Interactive comment on “Technical note: Single-shell $\delta^{11}\text{B}$ analysis of *Cibicidoides wuellerstorfi* using femtosecond laser ablation MC-ICPMS and secondary ion mass spectrometry” by Markus Raitzsch et al.

Dennis Mayk (Referee)

Received and published: 22 July 2020

Fig. 1.

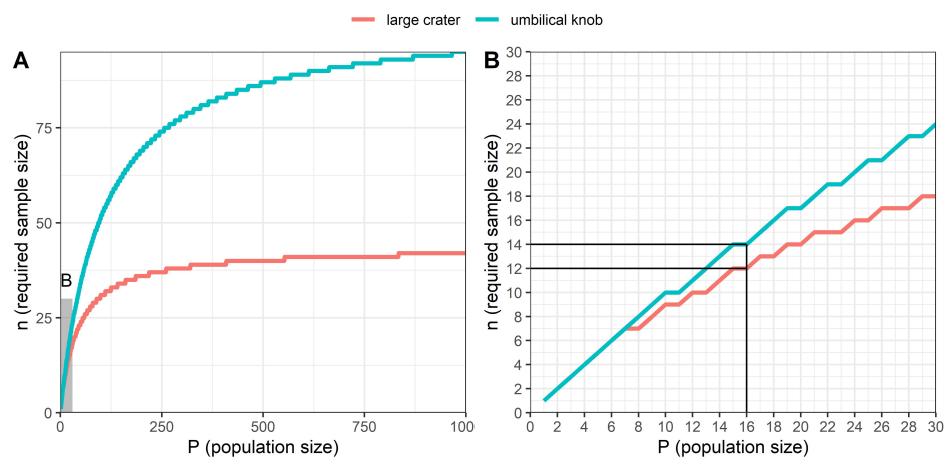
Considering the sample size of 16 or 18 it appears to be useful to consider the use of a conventional sample size estimation approach in comparison to a resampling approach as drawing from the same small population may result in errors. In the figure below, the estimated sample sizes required for $e = 0.5$ (2SD) and $1-\alpha = 0.05$ in relation to the population size is given as estimated by the R function “sample.size.mean()” (<https://CRAN.R-project.org/package=samplingbook>) for both measurement “types”. Given an overall population size of e.g., 500 specimens in the same pH-environment, it would require $n = 87$ specimens if the “umbilical knob” was measured and $n = 40$ if the “large crater” was measured (based on the variability observed in this study) to achieve the desired significance level. Even if the population size consisted of only 16 individuals, the estimated sample size would be $n = 16$ and $n = 14$, respectively and thus twice as large as reported in the manuscript.
